NUMBER: 23-042-20

GROUP: 23 - Body

SUBJECT:

Headlamp Condensation and Fogging

Fig. 3
Example Location Of Vent Caps - Charger

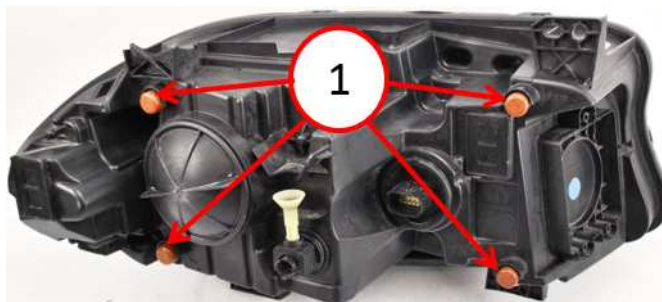
1. Remove the headlamp assembly. Refer to the detailed service procedures available in DealerCONNECT> Service Library> 8L - Lamps and Lighting / Lamps/Lighting - Exterior / Unit, Front Lamp/Removal.
2. Remove and discard the old vent caps by pulling them rearward off the headlamp assembly (Fig. 3) .

3. Install the new (brown) vent caps by pushing them on the bosses of the headlamp assembly.
4. Install the headlamp assembly. Refer to the detailed service procedures available in DealerCONNECT> Service Library>08 - Electrical/8L - Lamps and Lighting/Lamps/Lighting - Exterior/Unit, Front Lamp/Installation.
